Subject: Borg-Warner 3" and 4" Swing Check Valves

10 CFR PART 21 NOTIFICATION

(Reference No. CFRN-9301)

Required Angle of Disc Rotation and Axial Gap for Interference

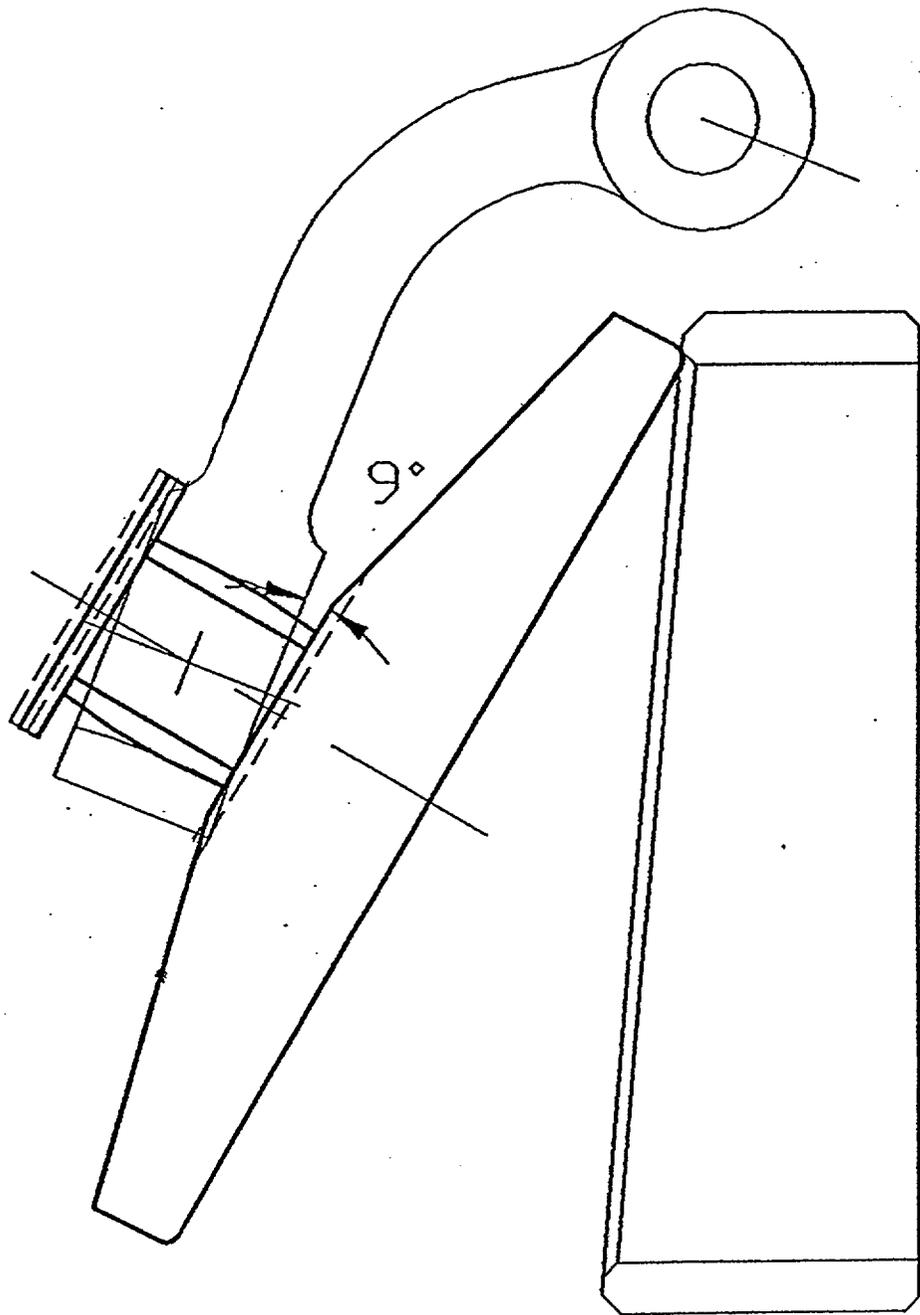
Valve 2CC-0697 did not fully close during pre-operational testing. Radiographs taken at the time of failure show the disk positioned at approximately 21° from the full closed position. The valve was disassembled. The top of the disk was found to be lodged under the seat lip preventing full closure. Valve 2CC-0693 subsequently failed testing in a similar manner. Both valves are located in the Component Cooling Water return lines from the Reactor Coolant Pump Motor Coolers and do not serve an active safety function. However the failure mechanism could apply to other valves that do provide a safety function.

Evaluation of the basic component by BW/IP indicates the root cause of the failure to close is due to the configuration of the attachment weld between the disk to the stud. Prior to 1977, this weld was placed on the back surface of the stud and extended into the bushing bore. In disks manufactured after 1977, the weld was recessed into the back surface of the disk and a final machine cut made to assure a flush surface.

This notice applies to all BW/IP 4-inch, 150#, bolted bonnet swing check valves which have a raised disk-stud retention weld on the back surface of the disk.

Corrective action is complete with the disk design modification identified above.

Licensees with valve installations effected by this notice should install a new disk component or refurbish the existing disk.
